## Planning Commission Vote Report

Subject: Change of Zoning Vote Report

Petition: P.Z. 14-2009 Chesterfield Fence (Chesterfield Fence and Deck Company)

Re: Chesterfield Fence (P.Z. 14-2009) 11/12/09 Issues Letter from PC Public Hearing on 11/9/09  
Chesterfield Fence and Deck (P.Z. 14-2009) – Ordinance No. 446 – Proposed Re-Zoning to “PI” Planned  
Industrial District at 18614 Olive Street Road. (Stock Project No. 207-4187.1)

# CHESTERFIELD FENCE AND DECK PRELIMINARY PLAN

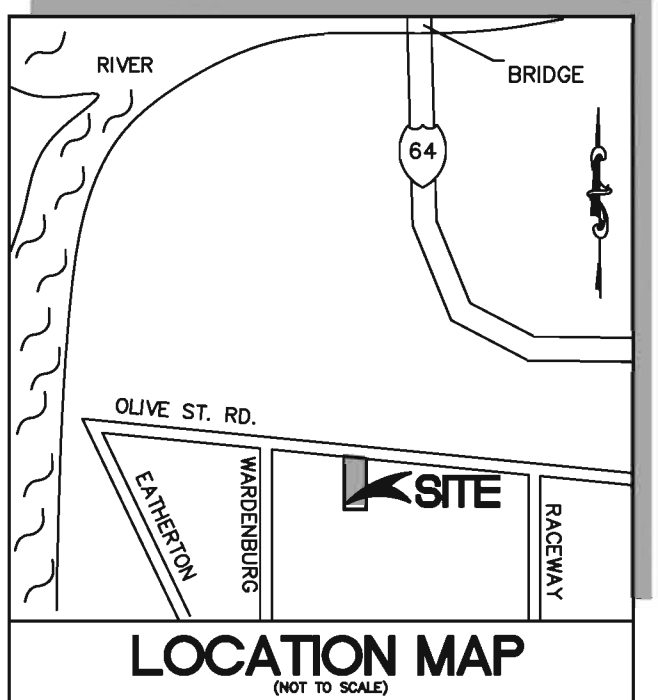
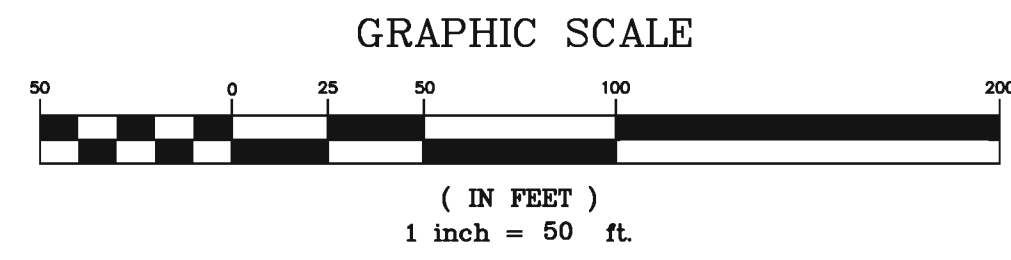
**1. Provide justification for the proposed request to reduce the required openspace from 35% to 30%.**

*Per Ordinance 2527 Section 1003.15 provides design criteria to “be reviewed by the City of Chesterfield during consideration of a request for a change in zoning to a PI District. While these features are not mandatory for approval, they are desirable to the City of Chesterfield and may increase the flexibility of design and the ability of the developer to negotiate the mitigation of other requirements.” In the hopes of mitigating the requirement of 35% open space, Chesterfield Fence and Deck is prepared to commit to the following as a part of future development on the subject property:*

**3. Review and revise the list of uses and address or remove the requested uses that the Spirit of St. Louis Airport has objected to.**

**4. Provide information on the request to reduce the building setback along the west, south, and east property line from 50 feet to 25 feet.**

**5. Provide information on the request to increase the maximum building height from 40 feet or 1 ½ stories, whichever is less; to 45 feet or 2 stories, whichever is less.**

- *A landscaped berm at the frontage of the property to provide a buffer area from Olive Street Road.*
- *A meandering sidewalk with benches alongside that will abut the previously mentioned landscaping.*
- *A 12' x 12' gazebo to provide a pedestrian common area alongside the previously mentioned meandering sidewalk (see attached.).*

*Response: The height of materials to be stored on the sight shall be no greater than 9 feet or three (3), three (3) foot tall storage containers stacked upon one another. This storage height would be one (1) foot taller than the existing fence along the north edge of the existing outdoor storage. The visual impact of this height of materials from adjacent roadways would be minimal considering that the outdoor storage is three hundred (300) feet from the Olive Street Road at its nearest point.*

*Response: The 50 foot setback carried over from the previous M3 Zoning, and was defined based on a preliminary plan showing a building 50 feet from the property line. The reduction of the setback to 25 feet was requested in an effort to become more consistent with the present day Planned Industrial Developments.*

*Response: The 40 foot height requirement carried over from the previous M3 Zoning. The increase in the maximum building height was requested in an effort to become more consistent with the present day Planned Industrial Developments.*

REVISD PER LETTER RESPONSE TO PLANNING COMMISSION DATED 11/16/09
